MONTGOMERY COUNTY HISTORIC PRESERVATION COMMISSION STAFF REPORT

Address:	10915 Kenilworth Ave., Garrett Park	Meeting Date:	4/19/2017
Resource:	Non-Contributing Resource (Garrett Park Historic District)	Report Date:	4/12/2017
Applicant:	Patrick Keating (Luke Olson, Architect)	Public Notice:	4/5/2017
Review:	HAWP	Tax Credit:	No
Case Number:	30/13-17A	Staff:	Michael Kyne
PROPOSAL:	Demolition of Non-Contributing resource and construction of new two-story house

STAFF RECOMMENDATION

SITE PLAN - OPTION #1.

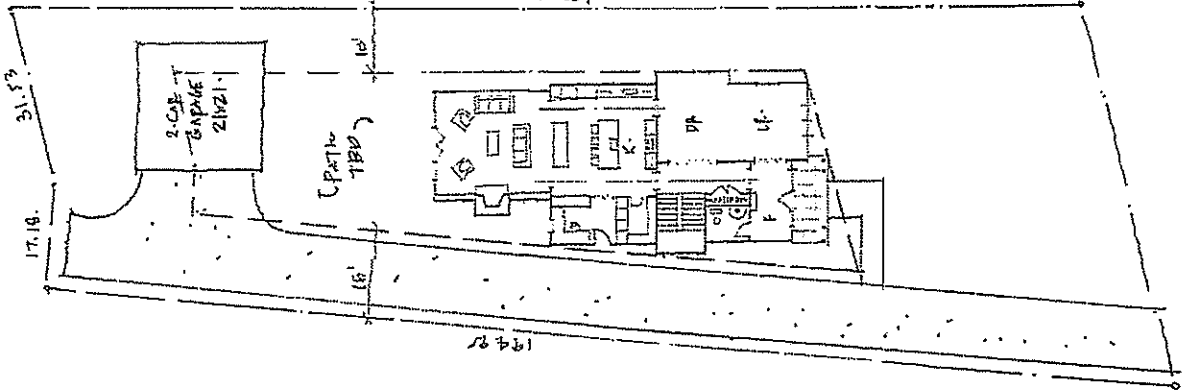
- The Commissioners unanimously preferred Option 1, with a rear porch and one-car garage.
- There was a preference for a contemporary design, without any traditional elements such as brackets or frieze boards.

7 MS. HEILER: I'd like to echo Commissioner's
8 Barnes' suggestions. I think you've been quite successful
9 at picking up some design elements from the neighborhood and
10 still coming up with a really very contemporary design. I
11 think the large windows are an important part of that
12 contemporary look. Staff asked us to comment on the
13 brackets and ornamentation on the bay. I think they're
14 probably minimally visible from the road, maybe not at all.
15 And, it may well be another example, picking up a little bit
16 of design hints from the neighborhood, so I don't object to
17 them. I wouldn't require them. I also agree with everyone
18 else that the smaller garage and the porch is a better
19 overall use of the space.

20 MS. SALISBURY-JONES: I don't have a lot to add.
21 I am in support of the project. The materials are fine. As
22 far as options go, I think, Option 1 is the better choice.
23 And the size and massing is appropriate, and compatible with
24 the neighborhood. And I appreciate that you're not trying
25 to replicate exactly, but taking cues from the style of the

The applicant has returned with a HAWP application and has addressed the Commission's previous concerns/preferences. The applicant proposes what was previously referred to as Option 1, which includes a rear porch and one-car garage. The previously proposed brackets under the second-floor bay on the left elevation have been removed.

SIDE (SOUTH) ELEVATION. OPTION #1

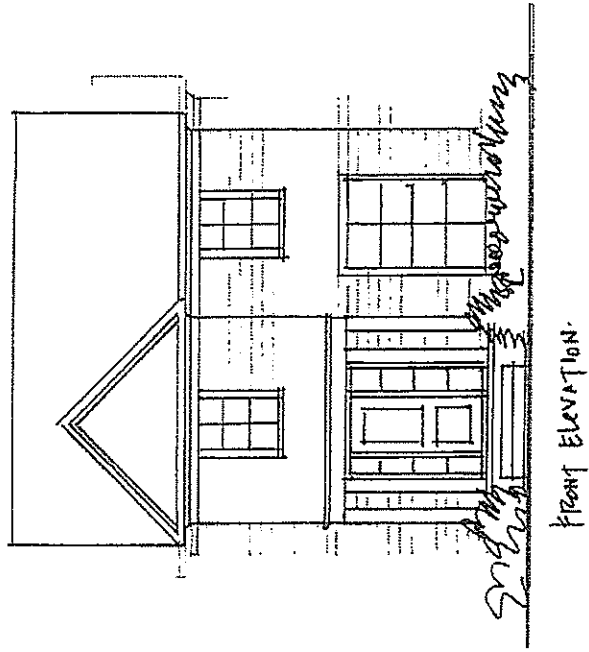
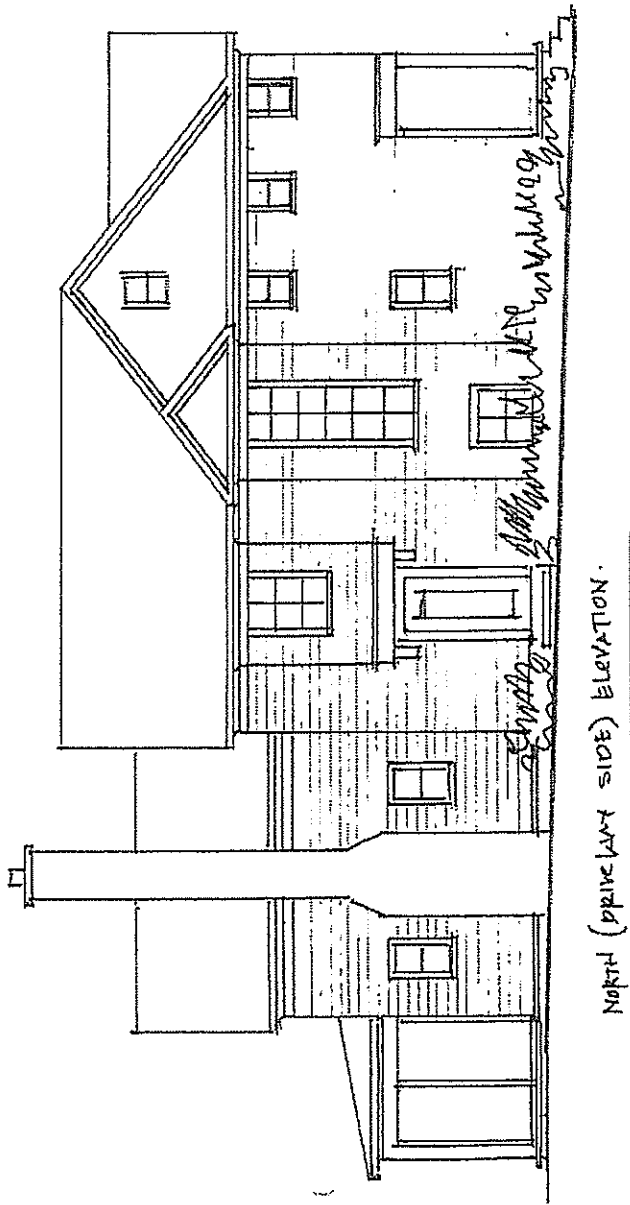
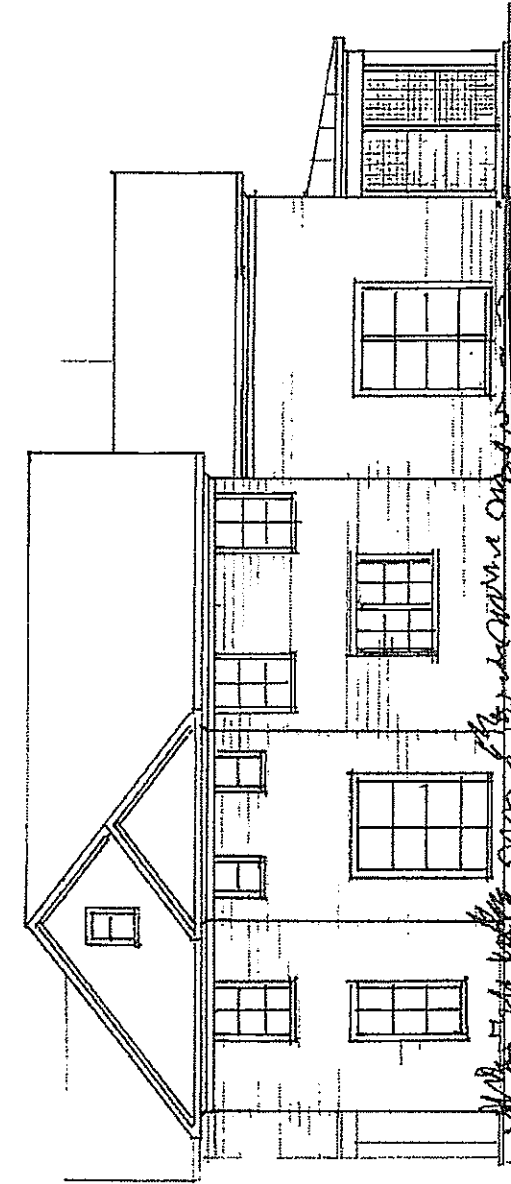
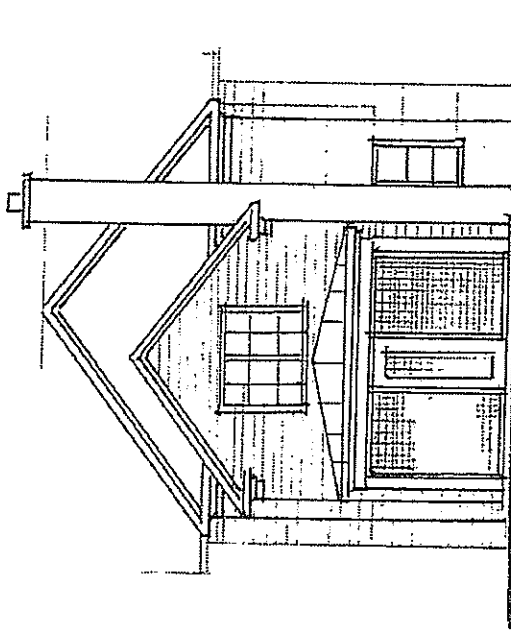
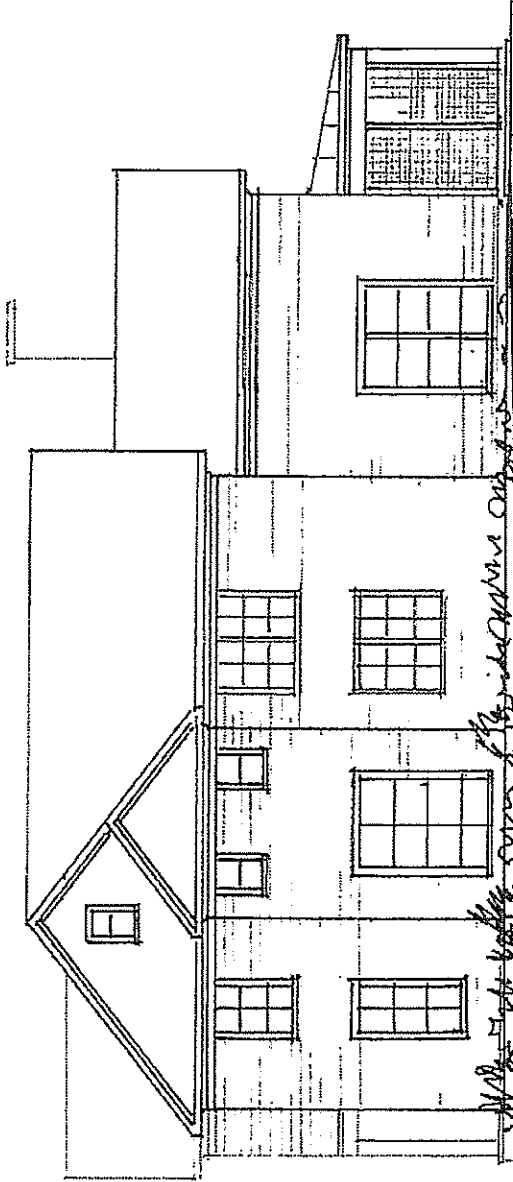
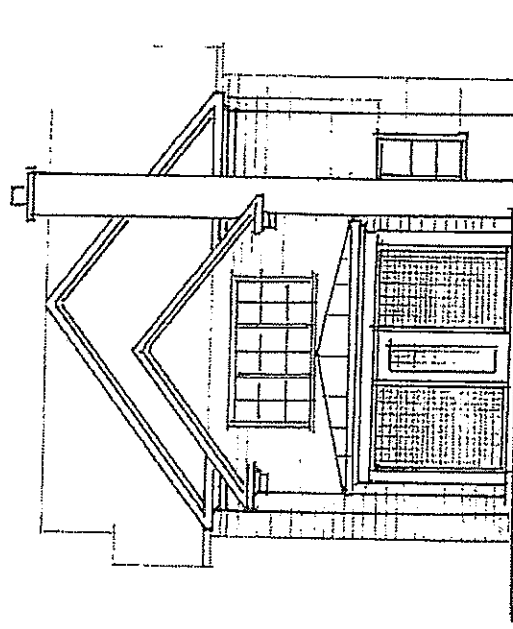
7 MS. BARNES: Since you visited the property, could
8 you tell me -- we've seen two variations on this rear porch,
9 one of which seems to have a terrace above. And, in your
10 experience having been there, do you think any of that would
11 be visible from the road?

20 MR. KYNE: And, I will note that this design is a
21 little different. The proposed design includes a recessed
22 porch under the sort of faux turret that's created by that
23 projecting front bay. And also, again, no side projecting
24 garage which we don't really like here.

11 MR. KIRWAN: I do have a question. Could you talk
12 about the porch, differences in the porches between the
13 drawings and the 3-D model, and the porch we see in your
14 example versus this one?

1 MR. KIRWAN: What about the detailing of the
2 screen panels. It looks much more contemporary in this
3 rendering versus the photograph example, versus the hand
4 drawing.
